J. A. JONES CONSTRUCTION COMPANY
SPECIAL PROCESS PROCEDURE
FOR
BACKFILL TEST FILL

WATERFORD SES UNIT NO.3
CONTRACT NO. W3-NY-4

SPECIAL PROCESS PROCEDURE	PROCEDURE NO. W-SP-8
TITLE: BACKFILL TEST FILL	REV. NO. 0 & DATE 5/27/76
PROJECT TITLE: WATERFORD SES UNIT NO. 3 CONTRACT NO. W3-NY-4	
<p>1.0 <u>PURPOSE</u></p> <p>This procedure outlines a means to determine the optimum construction techniques for the compaction of the backfill material to be used around the Plant Island Structure.</p> <p>2.0 <u>SCOPE</u></p> <p>The scope of the procedure will cover the construction and compaction of a test fill including compaction field testing, data compilation, tabulation and analysis. The final analysis of the data will result in a recommendation as to the number of passes required to attain density requirements.</p> <p>3.0 <u>REFERENCES</u></p> <p>3.1 Ebasco Services, Inc., Ebasco Specification, Filter and Backfill, LOU-1564.482, latest revision.</p> <p>3.2 J. A. Jones' Work Procedure, W-WP-12, "Backfill and Compaction".</p> <p>4.0 <u>DEFINITIONS</u></p> <p>None.</p> <p>5.0 <u>RESPONSIBILITIES</u></p> <p>5.1 Ebasco Services, Inc. shall provide a witness to test procedure.</p> <p>5.2 J. A.

SINGLE LIFT COMPACTION TEST FILL

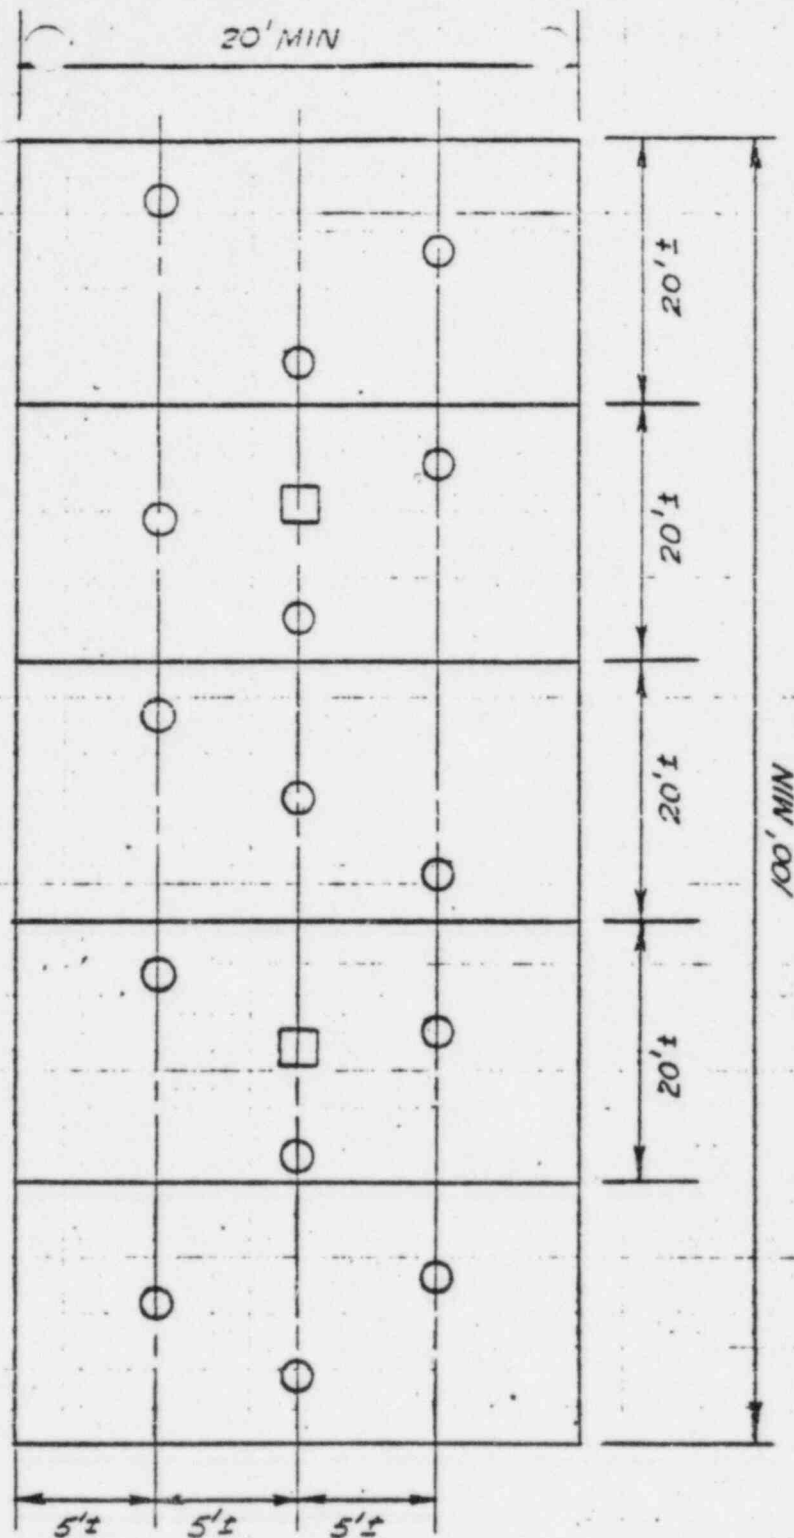
6.1.2.1 ~~6.1.2~~ In-place density tests ~~shall~~ ^{shall} be run in the approximate locations shown in Appendix A. The in-place density tests ~~shall~~ ^{shall} be performed using either of the following techniques and results recorded.

6.1.2.2 ~~6.1.2~~ Modified proctor compaction tests, ASTM D-1557-70 Method C, shall be run on samples in the approximate locations shown in Appendix A.

6.1.3 ~~6.1.2~~ The result of this test ~~shall~~ ^{fill shall} be plotted on graph (Appendix B) as the percentage (%) ^{compaction} versus number of passes and a specific number of passes selected as optimum. The laboratory standard used as a base for the determination of the percentage (%) compaction shall be the modified proctor density as determined from the ASTM-D-1557-70 Method C test. The percentage (%) compaction shall be defined as the in place density (#/ft³) divided by the base laboratory density (#/ft³) X 100.
